Project	IEEE 802.16 Broadband Wireless Access Working Group < http://ieee802.org/16 >	
Title	Clarification on the Key Hierarchy for the PKMv2	
Data Submitted	2005-06-08	
Source(s)	Seokheon Cho Sungcheol Chang Chulsik Yoon	Voice: +82-42-860-5524 Fax: +82-42-861-1966 chosh@etri.re.kr
	ETRI 161, Gajeong-dong, Yuseong-Gu, Daejeon, 305-350, Korea	
Re:	IEEE P802.16e/D8	
Abstract	<p>Both an MS and the BS can share the PAK from the RSA-based authorization and the PMK from the EAP-based authorization in the PKMv2. Two keys, the PAK and the PMK, are used to derive the AK. The PAK is used as input data, however, the PMK is used as input key. Since the PAK and the PMK are root keys to derive the AK, both of them should be used as not input data but input keys.</p> <p>This contribution provides key hierarchy for the PKMv2.</p>	
Purpose	Adoption of proposed changes into P802.16e/D8	
Notice	This document has been prepared to assist IEEE 802.16. It is offered as a basis for discussion and is not binding on the contributing individual(s) or organization(s). The material in this document is subject to change in form and content after further study. The contributor(s) reserve(s) the right to add, ame

Figure 131-AK with **the only PAK** (from RSA-based ~~only~~ authorization process)

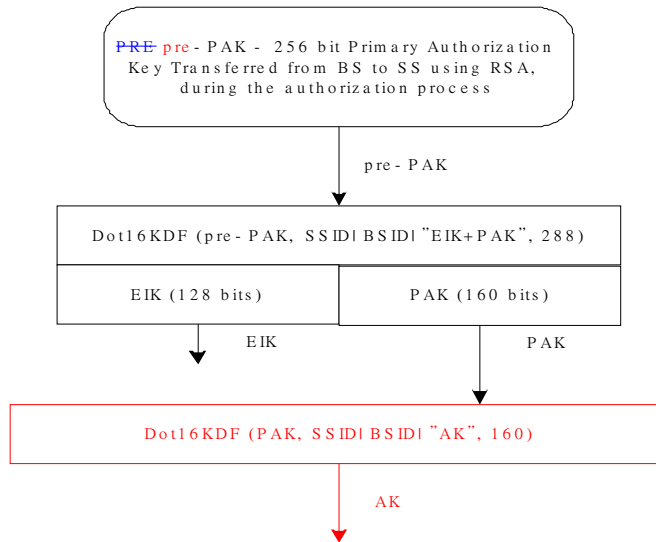
Figure 131 outlines the process to calculate the AK when the ~~RSA-based~~ authorization process has taken place, but where the EAP-based authentication process hasn't taken place, or the EAP method used has not yielded an ~~AAA-key~~ MSK:

Figure 132-AK with **PAK and PMK**

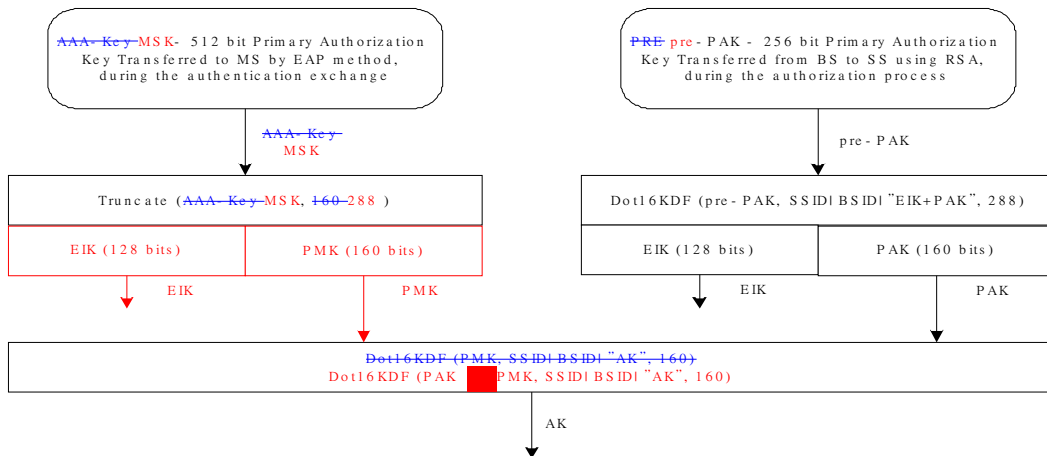
Figure 132 outlines the process to calculate the AK when both the **RSA-based** authorization exchange has taken place, yielding a PAK and the EAP based authentication exchange has taken place, yielding an **AAA-key MSK**:

Figure 133-AK with the only PMK (from EAP-based only authentication authorization process)

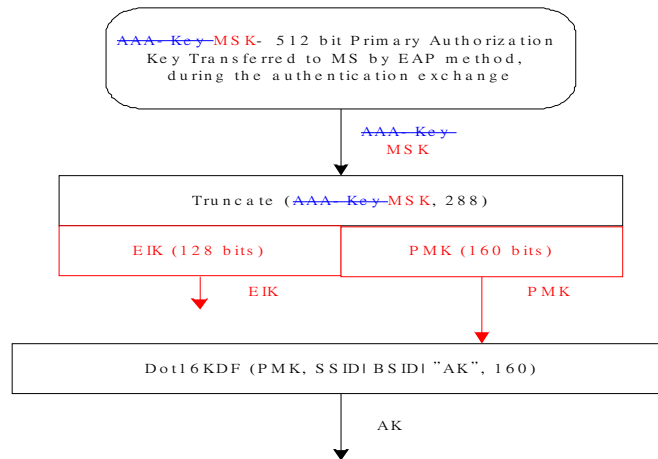
Figure 133 outlines the process to calculate the AK when only the EAP based authentication exchange has taken place, yielding an **AAA-key MSK**:
